FIELD REPORT – CARILLON POINT BUILDING 4000 **– FIELD REPORT**
Report Number: 4

Project No. 10-030608K1 **Inspection Date:** June 17, 2016

Job Address:
4000 Carillon Point
Kirkland, Washington

This writer was on site on June 17, 2016 to review the installation of the roof assembly at the southwest area of the Main Roof. The following roofing related observations were made:

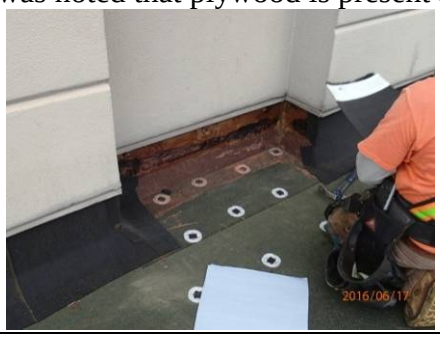
4.6 At the base of the rising screen wall and skylight/mechanical curbs, perlite cant strip is installed and Siplast TA-119 primer is applied to the substrate. The primer is allowed to flash off prior to installation of the Paradiene 20 SA. It was noted that plywood is present at the base of the mechanical walls.

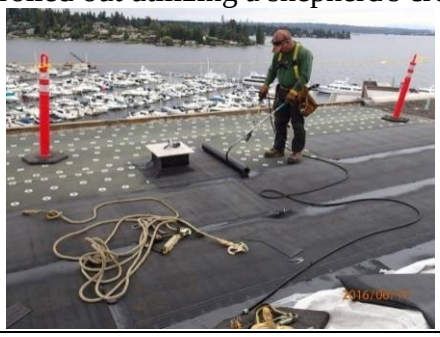
4.7 Siplast Paradiene 20 TG is rolled out utilizing a shepherd's crook and torch applied over the basesheet.

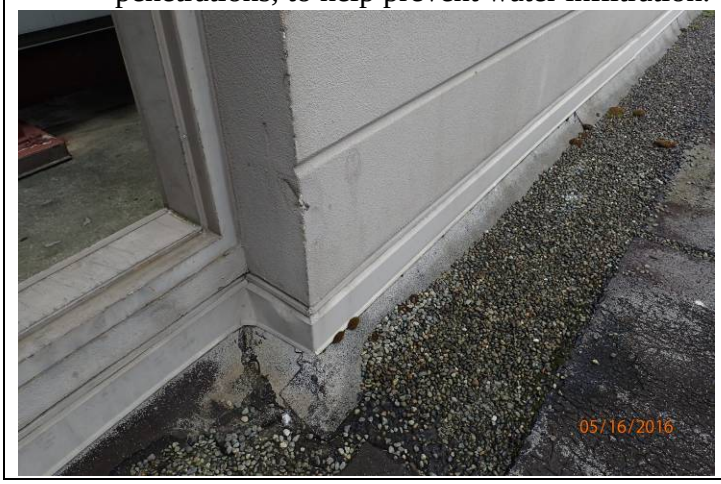
1.6 EIFS on Penthouse Walls: There is existing damage and penetrations to the EIFS on the penthouse walls. A few locations were photographed during the site visit. SR Bldg Services should document all damage prior to work. It is suggested that Carillon Properties repair damaged areas, and areas with penetrations, to help prevent water infiltration.
